Detailed Site Plan DET-2023-013
Major Departure MJD-2024-004
Alternative Compliance ACL-2024-005
Largo Park, Lot 6

STAFF REPORT

SUBJECT: Detailed Site Plan DET-2023-013
Major Departure MJD-2024-004
Alternative Compliance ACL-2024-005
Type 2 Tree Conservation Plan TCP2-136-03-04
Variance to Section 27-4204(f)(3)
Largo Park, Lot 6

Figure 5.15 Micro-Bioretention (Variation 2 - Parking Lot)

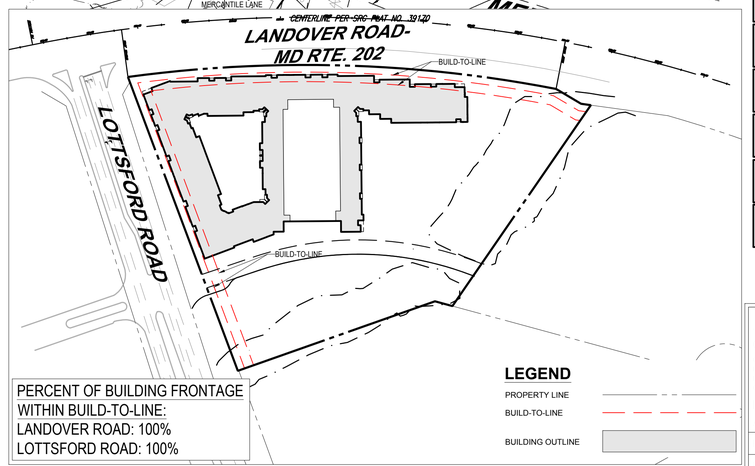
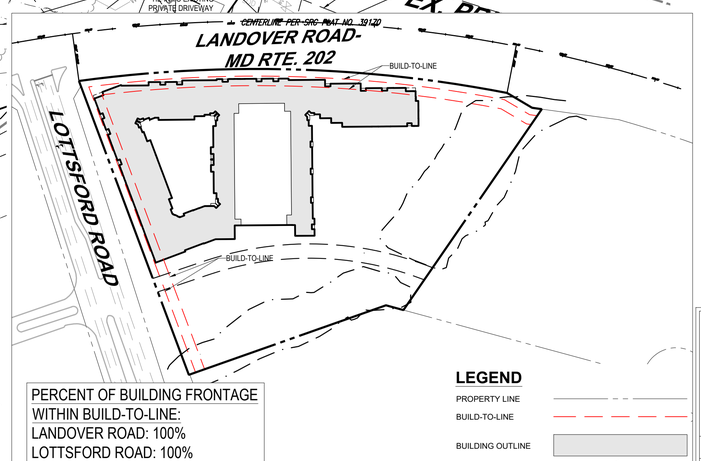
Analysis: Figure 5.15 on Sheet C-301 of the detailed site plan civil drawings shows micro-bioretention details. These bio-retention areas should be included as much as possible on the site, particularly along streets for stormwater management. The applicant is encouraged to include

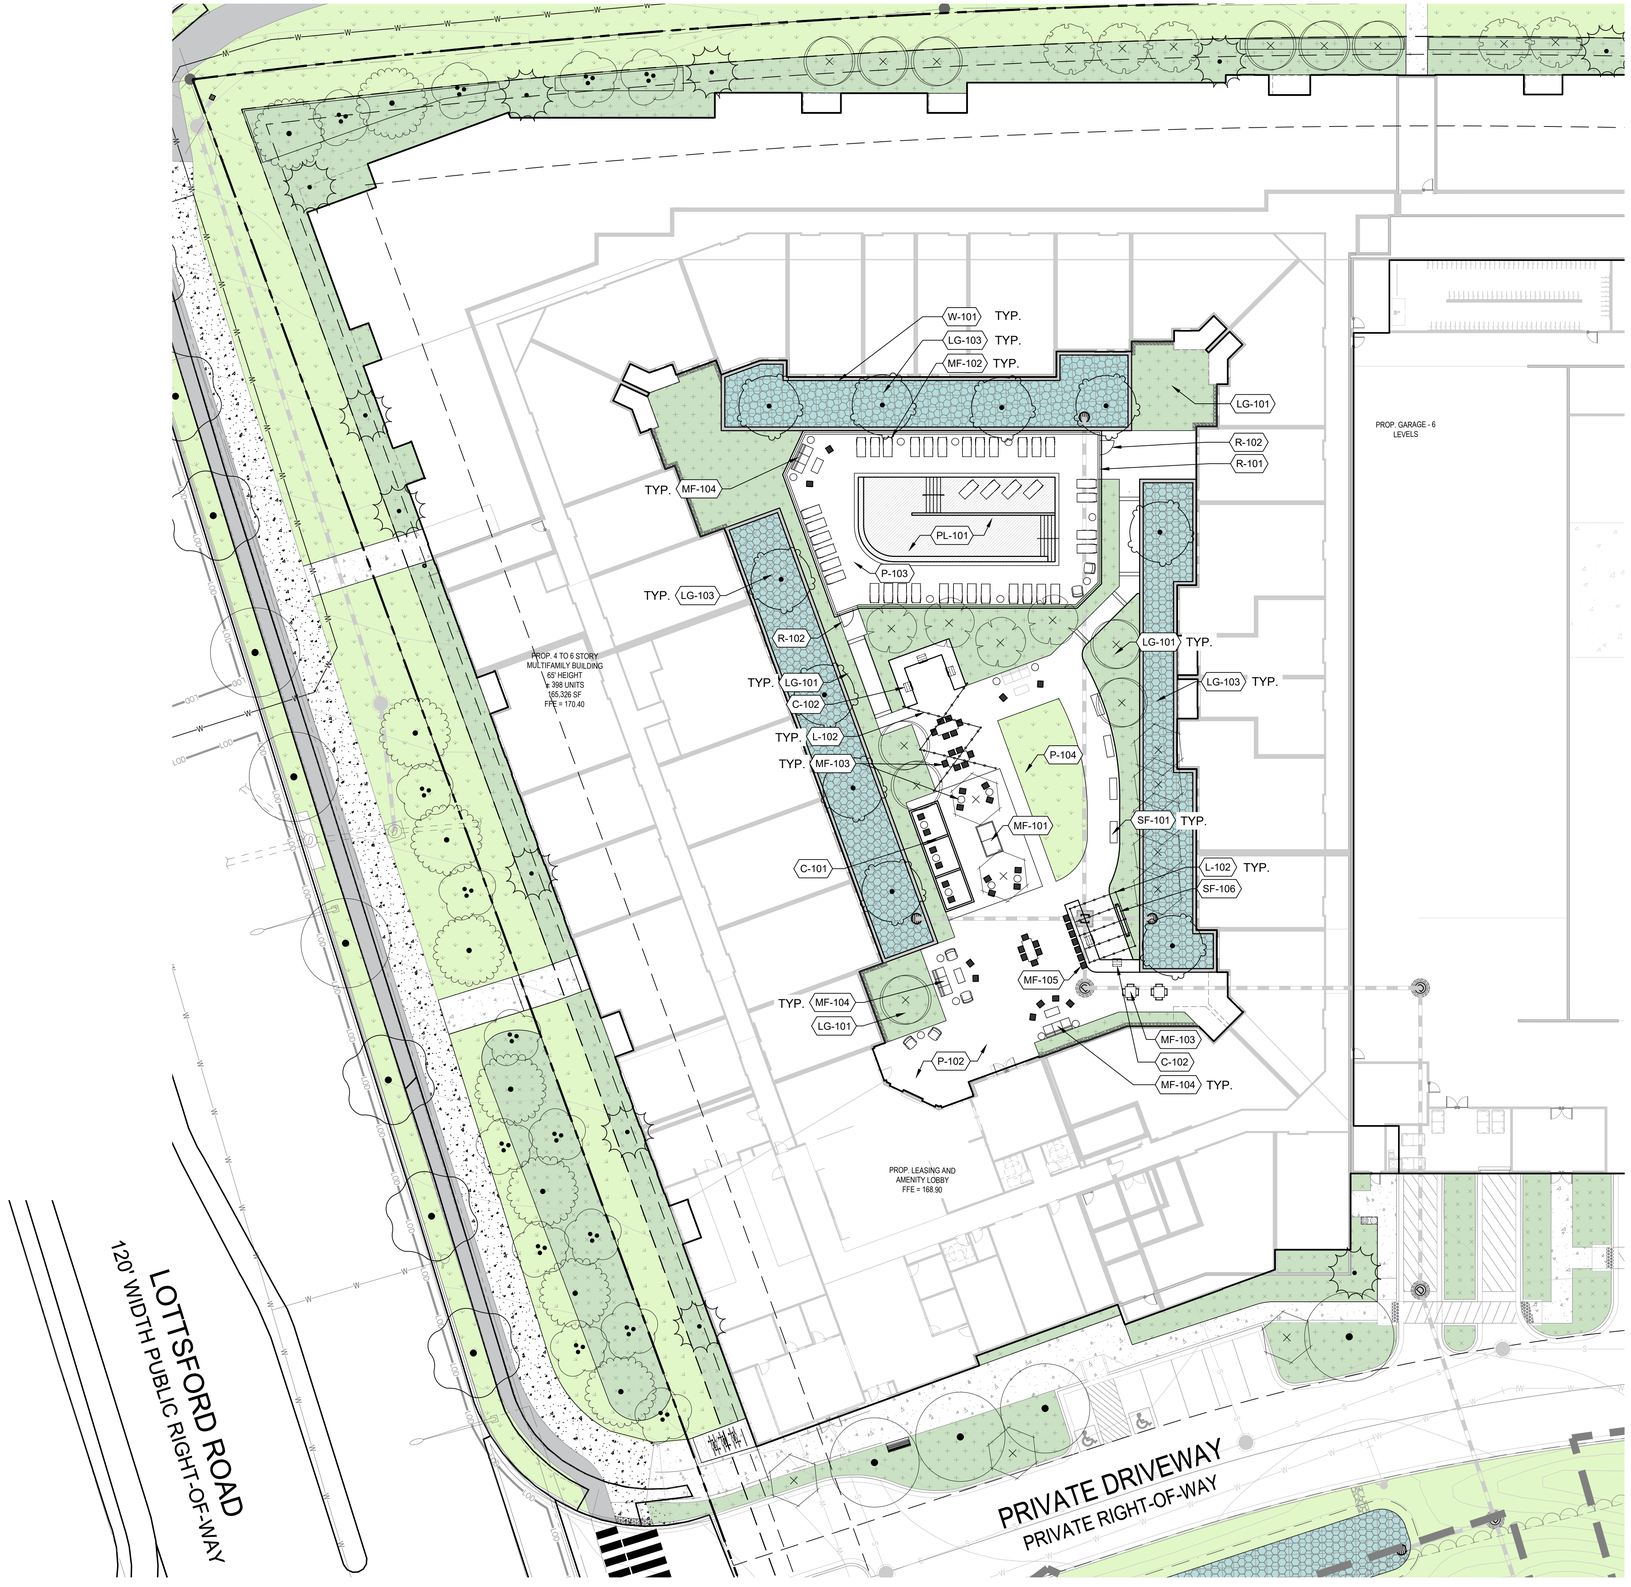
(2) Remove the proposed work pods from the list of recreation facilities on Sheet L-0102.

L0401

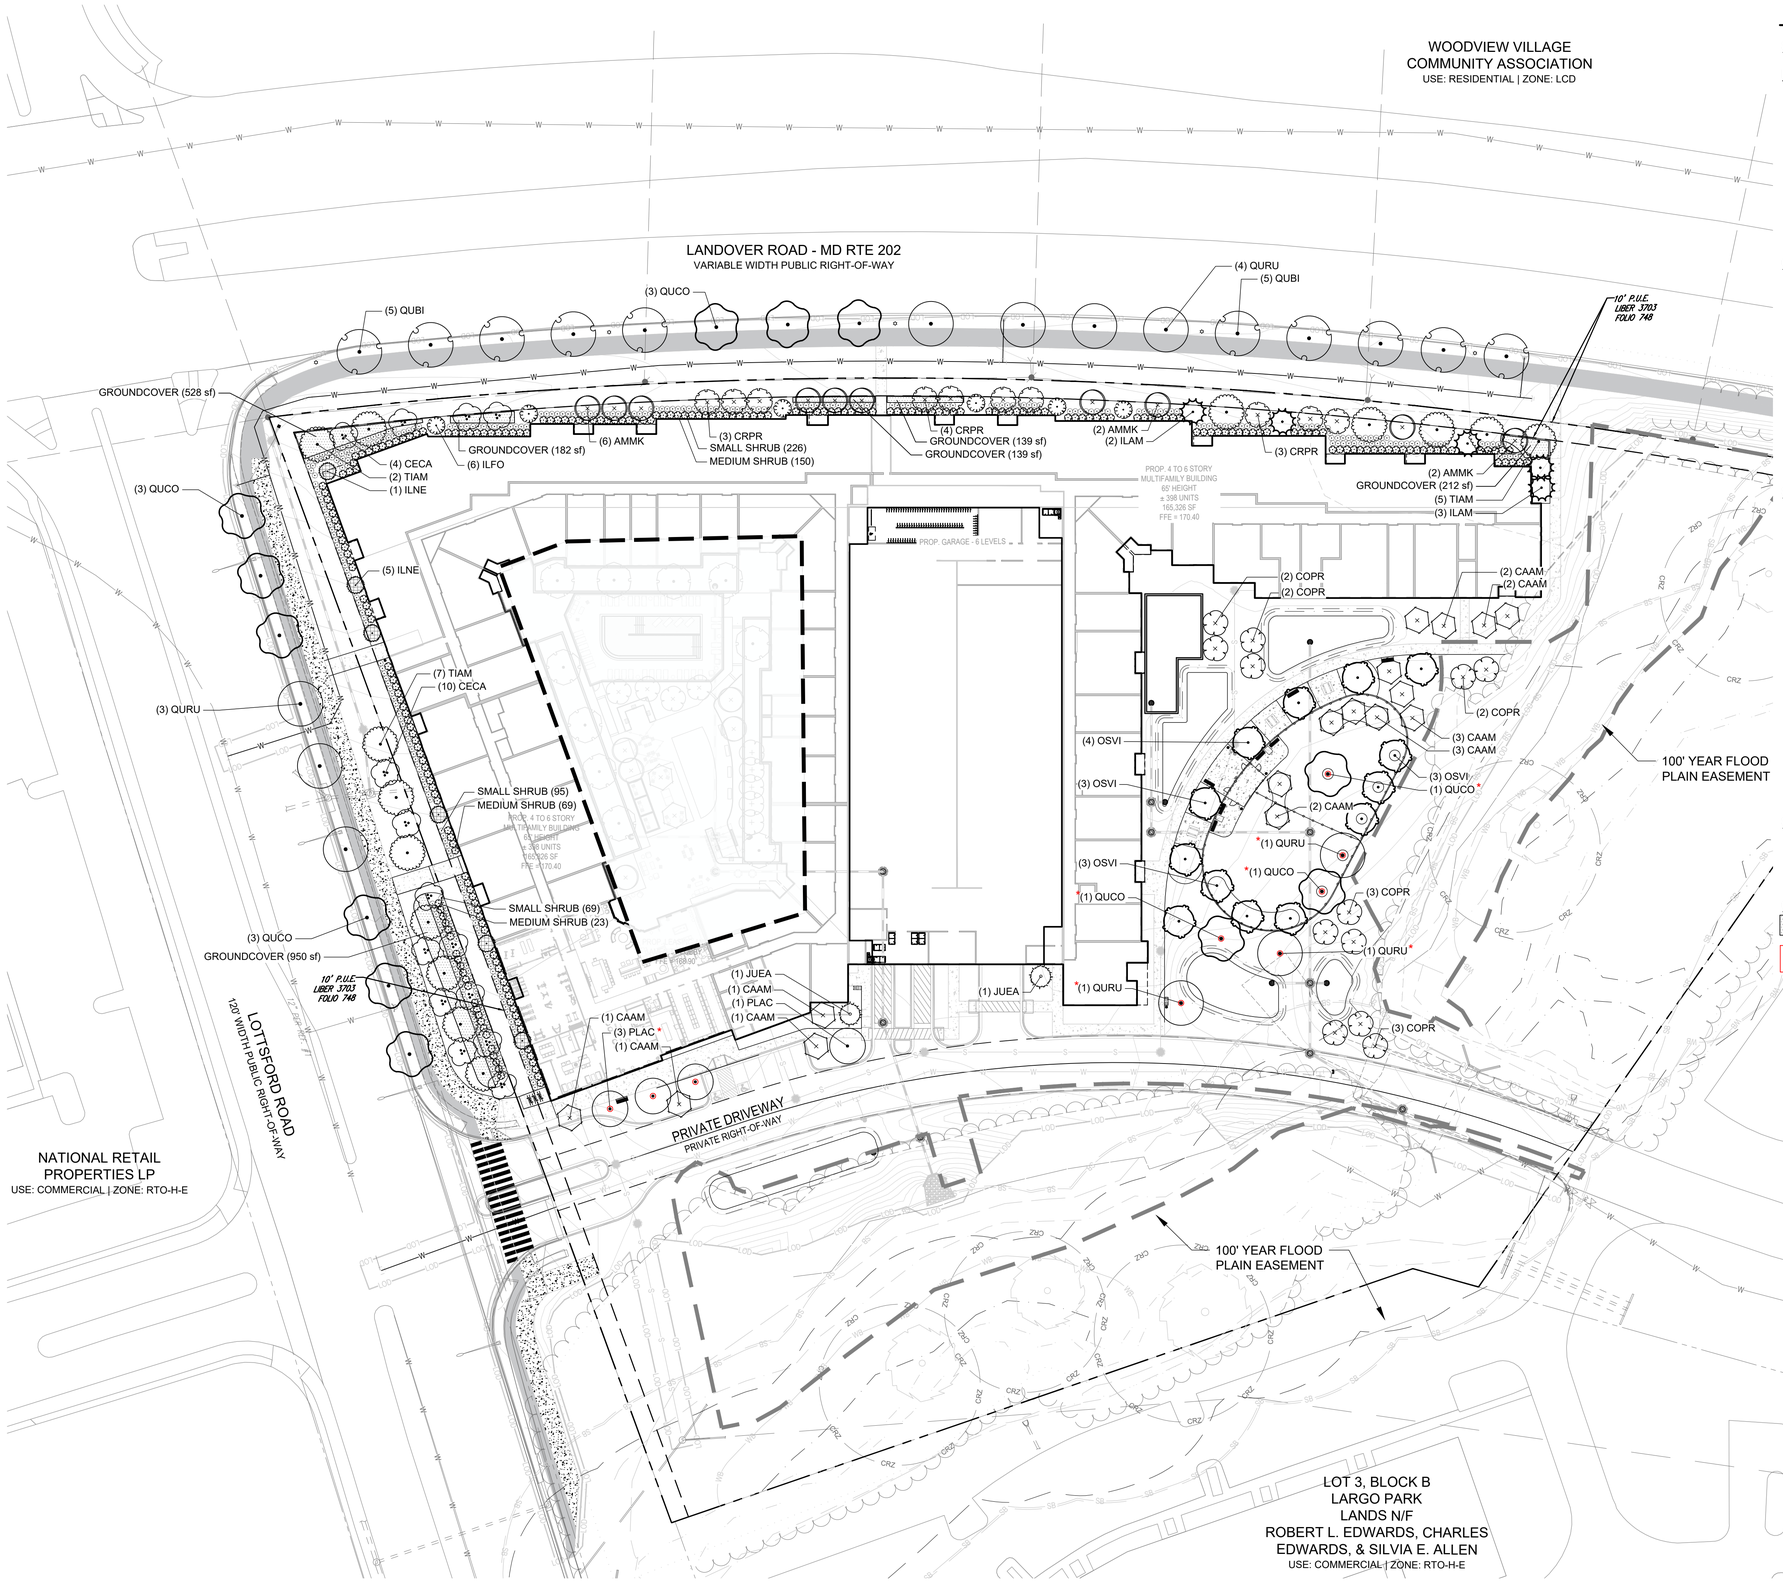
(2) Remove the labeling of "proposed monument sign" on Sheet L-0401 and ensure no such labeling is included throughout the submission, in accordance with Section 27-61505 of the Prince George's County Zoning Ordinance.

5. Remove the two monument sign labels on Sheet L0401 and C-301, as they are no longer proposed.

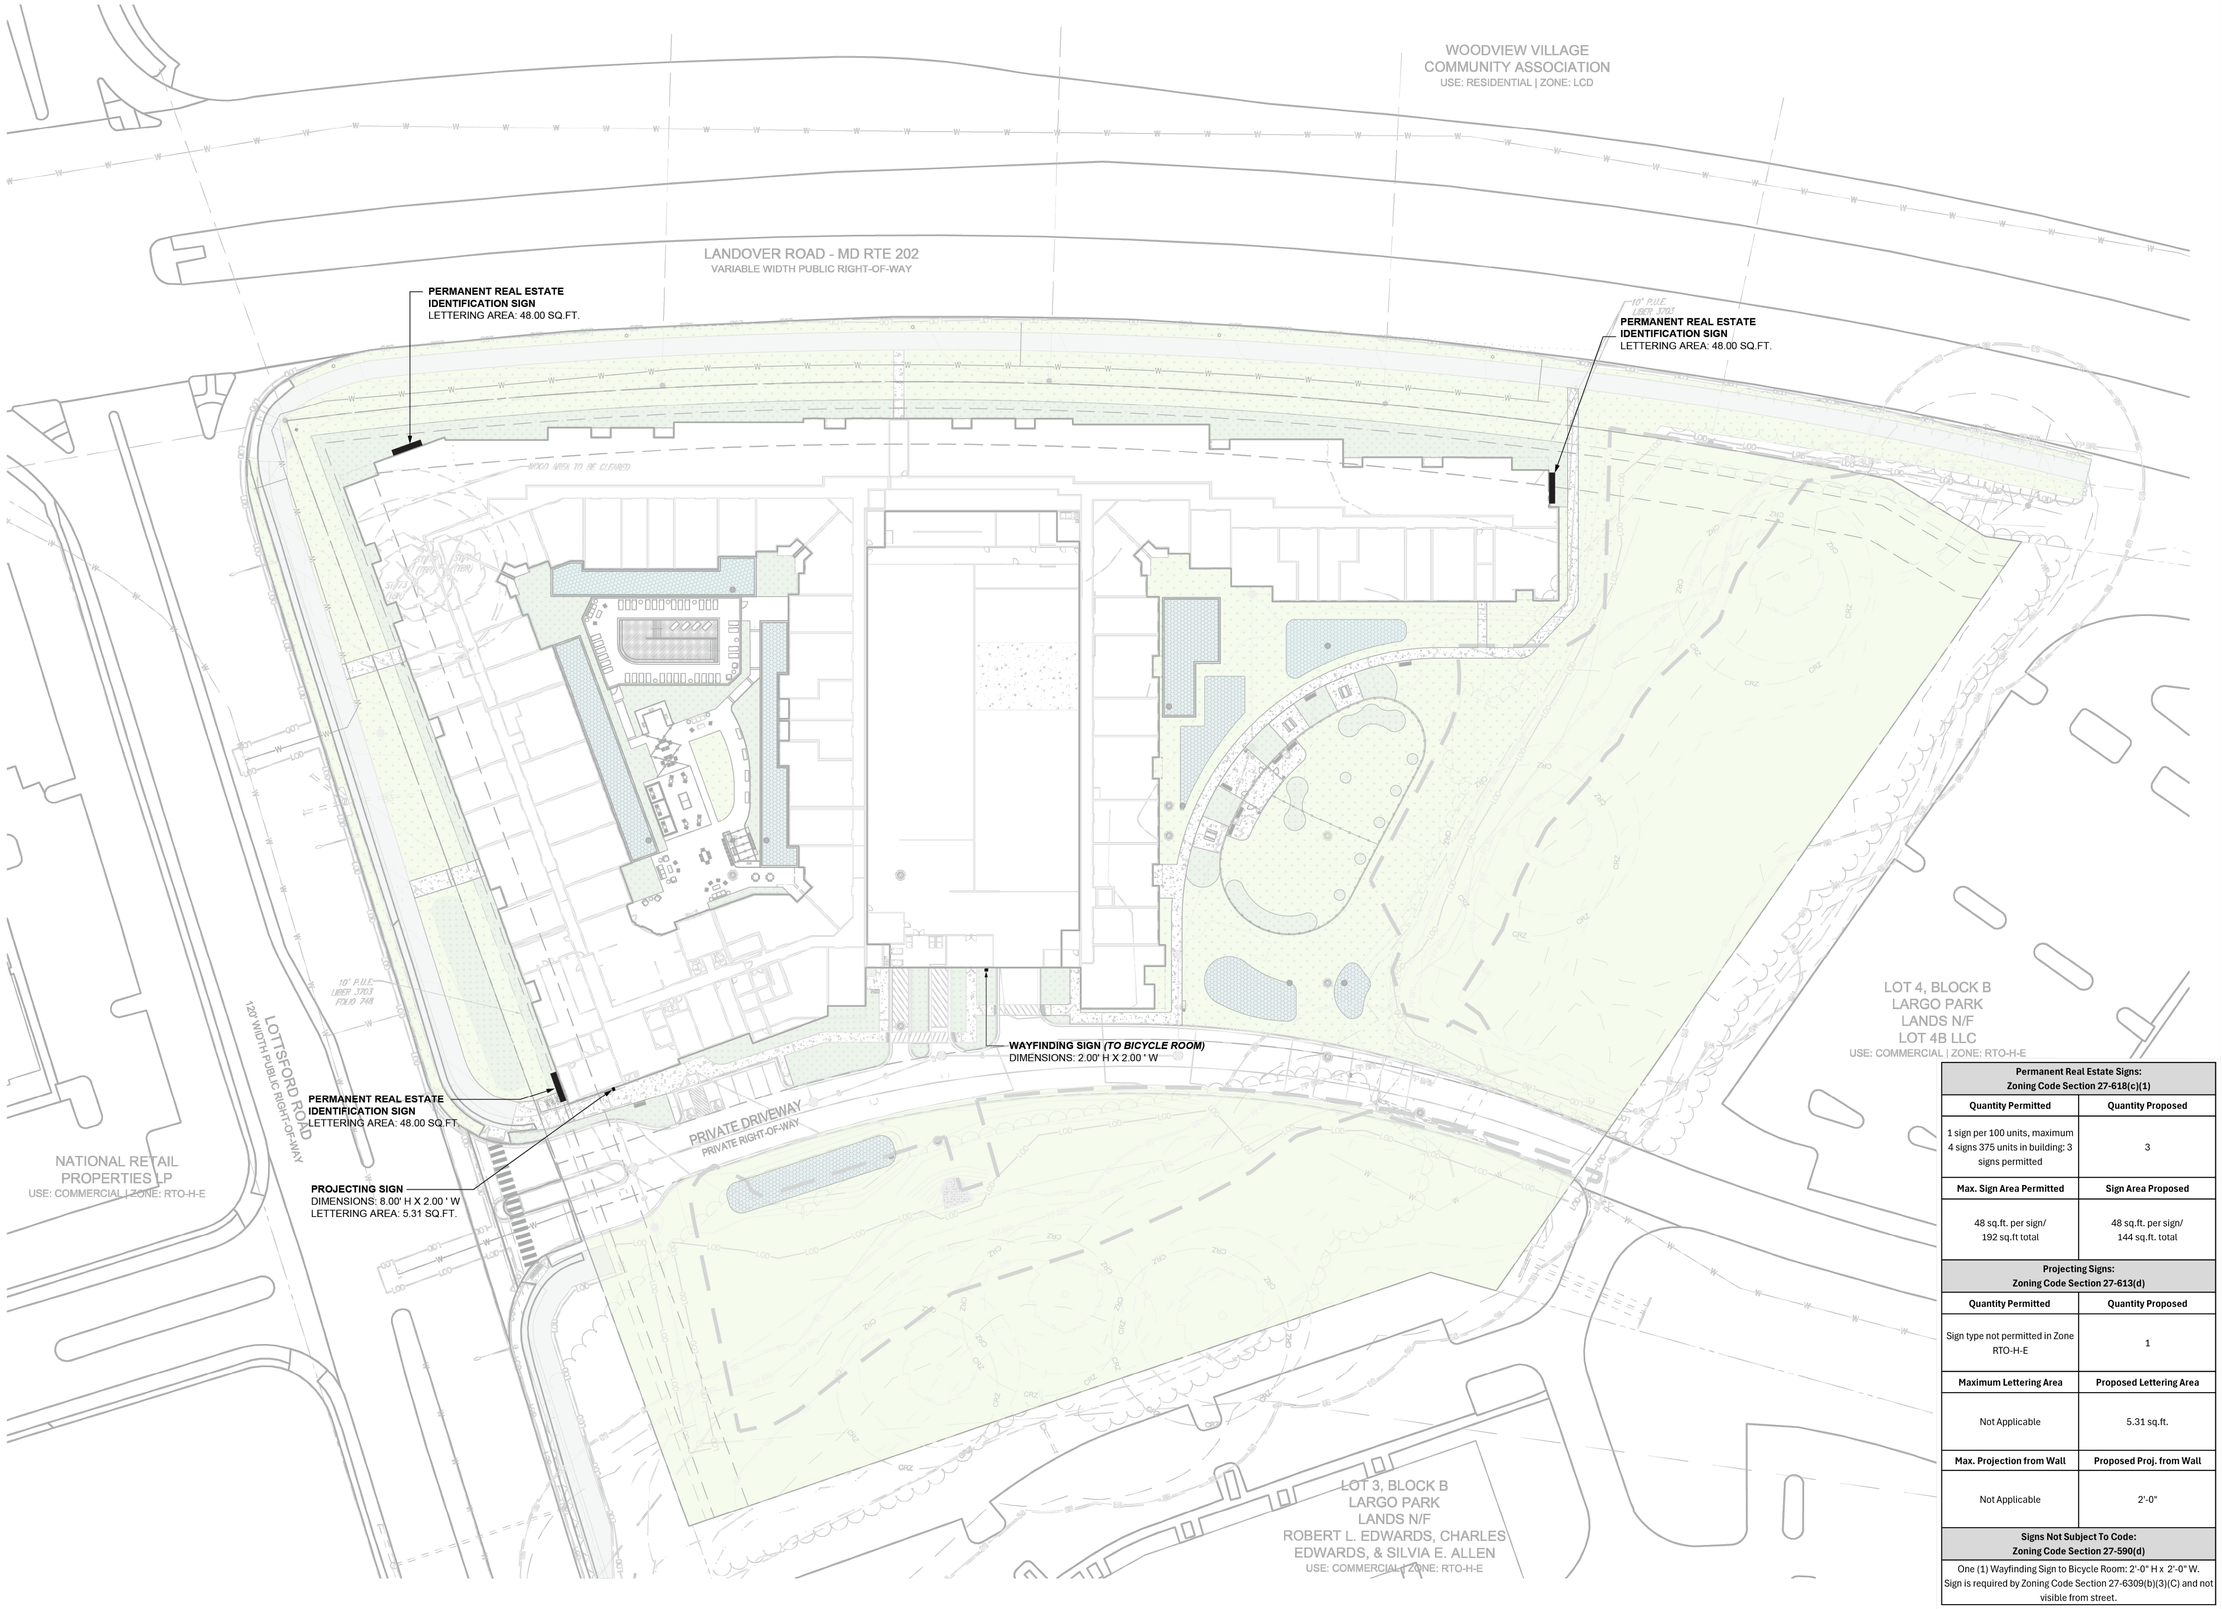
(1) Correct the information in the signage schedule on Sheet L-0701, including the refenced sections, the number of proposed multifamily dwelling units, and information related to projecting signs, in accordance with Section 27-61505 of the Prince George's County Zoning Ordinance.

3. On Sheet L0701 the applicant is proposing a sign listed as not permitted in this zone. Correct the note.
